### **Service Campaign Bulletin**

Campaign No. 2023090009, March 2024

SUBJECT: Model EQS (297 platform)

Inspect Front Left and Right Wheel Well Reinforcement

Figure 1, (Left wheel well)

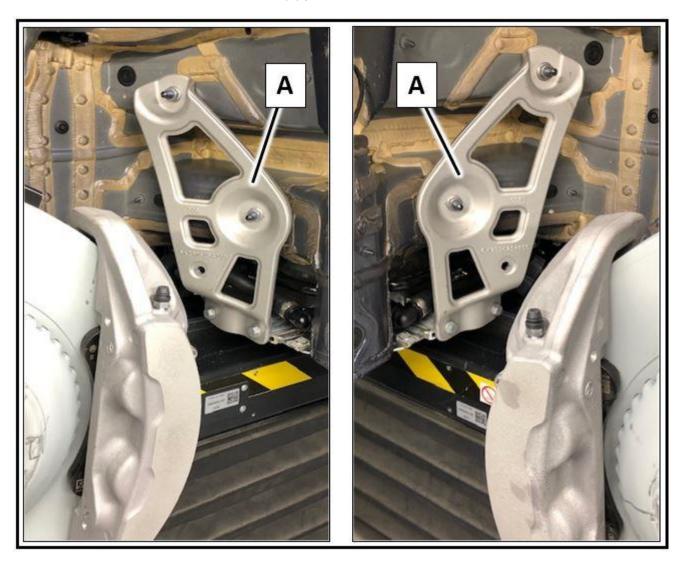
- 1. Lift vehicle on vehicle lift.
  - i For basic data, see AR00.60-P-1006A.
- 2. Remove center section of lower engine compartment lining.
  - i For basic data, see AR61.20-P-1105EQS.
- 3. Visual check if reinforcement is installed in both left and right front wheel wells (A, Figures 1 and 2).
  - a. Reinforcement on wheel well (A) not present: Carry out work procedure.
  - b. Reinforcement on wheel well (A) present: End measure.

1.	For basic data, see AR40.10-P-1102A.
2.	Remove rear section of front fender liner from affected side.  i For basic data, see AR88.10-P-1301EQS
3.	Retrofit reinforcement on wheel well as shown (A, Figures 1 and 2) on the affected side(s).  i Tighten screw with 30 Nm torque.  i Tighten nut with 30 Nm torque.
4.	Assemble in reverse order.
